ADDENDUM No. 3

BID #5792

LINCOLN CENTER HVAC & ROOF REPLACEMENT

Revised roof plan

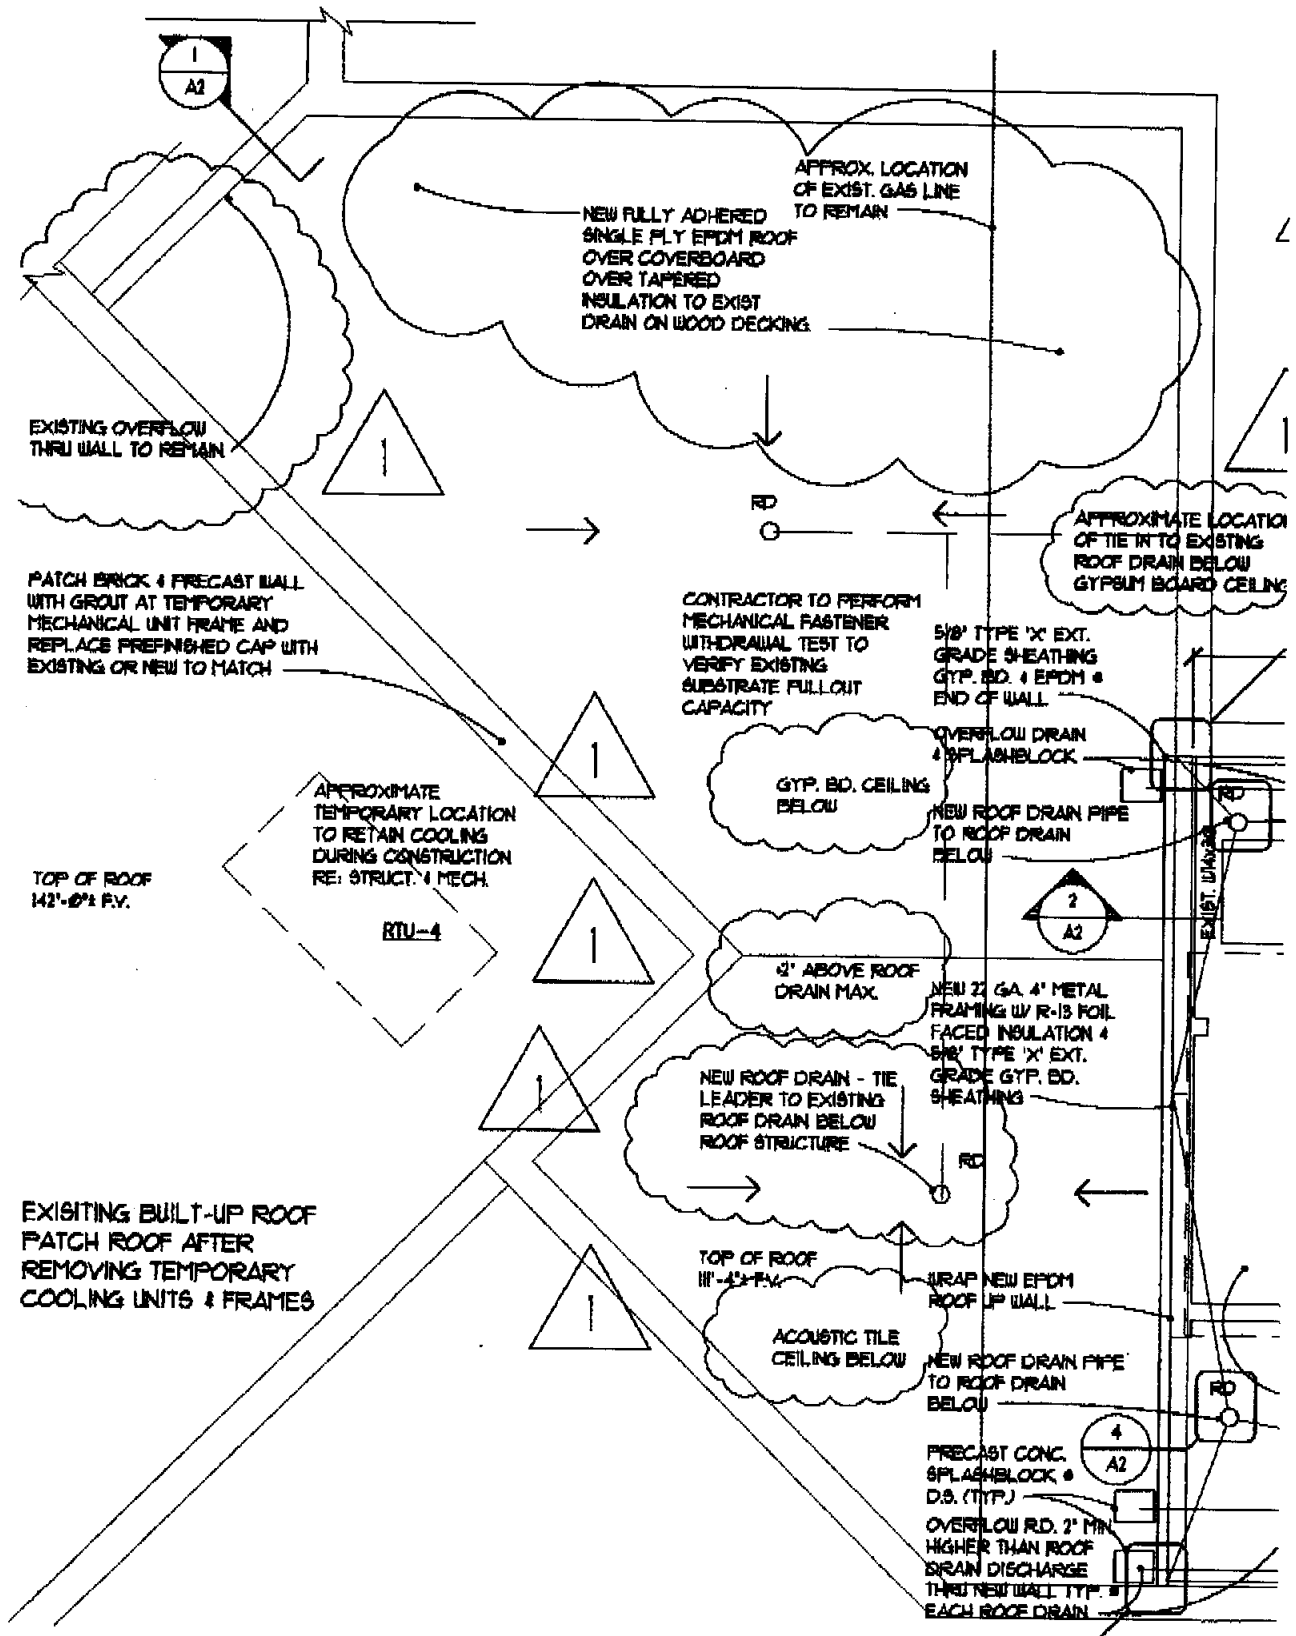
There are two (2) layers of existing roofing on the lower roof; roofing, insulation and flashing on the south side of the new parapet wall shall be removed to the wood deck below. There is no known asbestos in the roofing, flashing or insulation.

Existing piping, ductwork and conduit are to remain or be replaced after re-roof unless otherwise noted on the plans.

The W14X30 on the south end is existing to remain.

Install new roof drains, tapered insulation, and flashing on the roof south of the new parapet that previously was to have been re-roofed.

3
S2.2

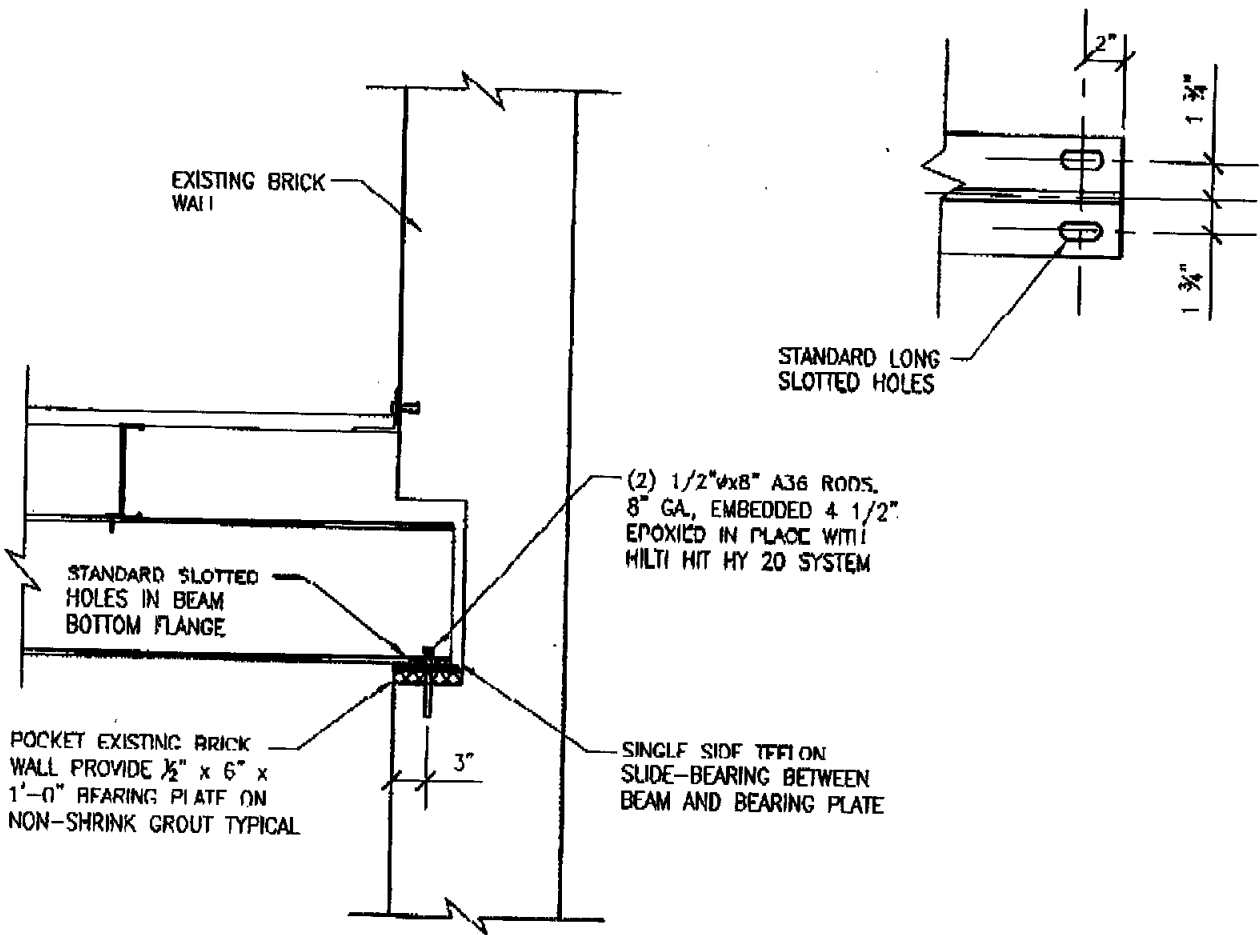
The support column at the existing beams are existing.

The new W12x26 shall be the entire width of the space with a new column support on the parapet wall and attached per detail 3/S2.2

The C8x11.5 shall be continuous along the east wall and broken or notched at the existing beams after verifying exact precast wall panel locations.
